**Subject: ENERGY STAR® criteria revisions**

Thank you for allowing us the opportunity to provide input regarding the upcoming ENERGY STAR revisions. We would like to submit the following comments for your consideration concerning the proposed draft side-hinged door criteria and analysis published on August 6, 2008:

Figure 1

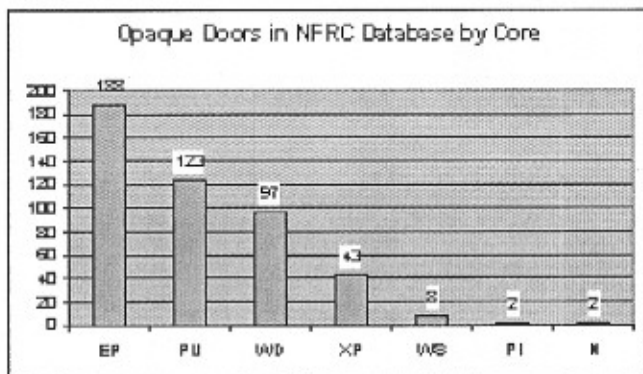
If criteria are variable by percent of glazing, we request the 1/2-lite values be adjusted to reflect the same glazing required by the full lite values (see Table 1). Simulations have demonstrated that the glazing required attaining a 0.32 U-factor in a full lite door will result in a 0.27 U-factor in a 1/2-lite door of identical construction and glazing.

Figure 2

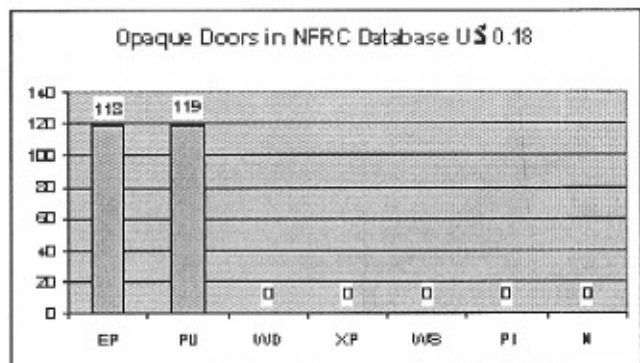
We acknowledge that there is great opportunity for improvements in efficiencies with opaque door units. Opaque entry doors constitute a large percentage of the market. Therefore, we believe a more aggressive value for Phase 1 would better differentiate energy efficient products. Of the 463 opaque door records ( $VT \leq 0.00001$ ) in the NFRC database, 237 of them already perform at 0.18 or better (Fig 1 and Fig 2). We believe this would be an appropriate value that is achievable with current technologies.

Figure 1

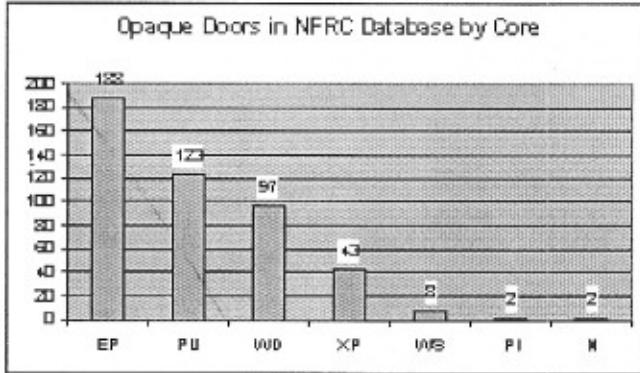
If criteria are variable by percent of glazing, we request the ½-lite values be adjusted to reflect the same glazing required by the full lite values (see Table 1). Simulations have demonstrated that the glazing required attaining a 0.32 U-factor in a full lite door will result in a 0.27 U-factor in a ½-lite door of identical construction and glazing.

Figure 2

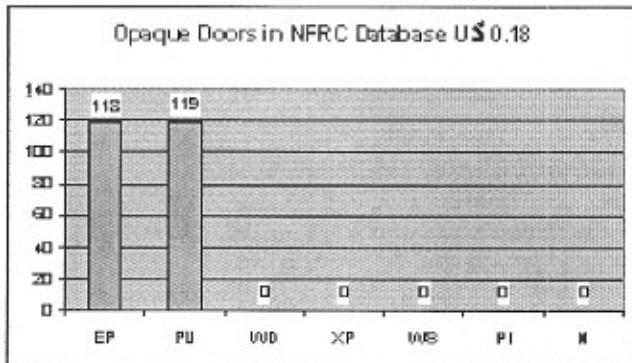
We acknowledge that there is great opportunity for improvements in efficiencies with opaque door units. Opaque entry doors constitute a large percentage of the market. Therefore, we believe a more aggressive value for Phase 1 would better differentiate energy efficient products. Of the 463 opaque door records (VT ≤ 0.00001) in the NFRC database, 237 of them already perform at 0.18 or better (Fig 1 and Fig 2). We believe this would be an appropriate value that is achievable with current technologies.

Figure 1

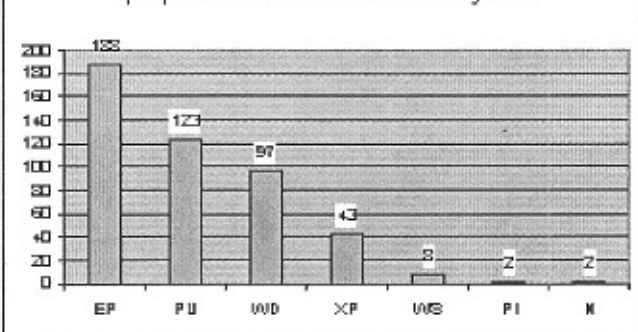
We acknowledge that there is great opportunity for improvements in efficiencies with opaque door units. Opaque entry doors constitute a large percentage of the market. Therefore, we believe a more aggressive value for Phase 1 would better differentiate energy efficient products. Of the 463 opaque door records ( $VT \leq 0.00001$ ) in the NFR database, 237 of them already perform at 0.18 or better (Fig 1 and Fig 2). We believe this would be an appropriate value that is achievable with current technologies.

Figure 1

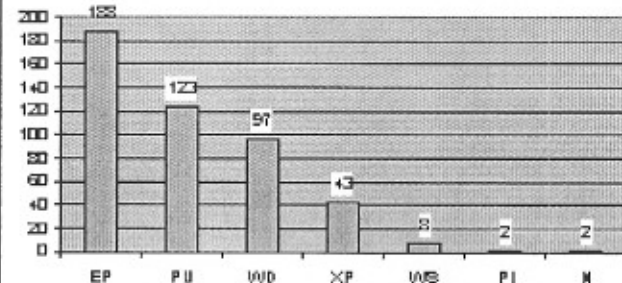
We acknowledge that there is great opportunity for improvements in efficiencies with opaque door units. Opaque entry doors constitute a large percentage of the market. Therefore, we believe a more aggressive value for Phase 1 would better differentiate energy efficient products. Of the 463 opaque door records ( $VT \leq 0.00001$ ) in the NFRC database, 237 of them already perform at 0.18 or better (Fig 1 and Fig 2). We believe this would be an appropriate value that is achievable with current technologies.
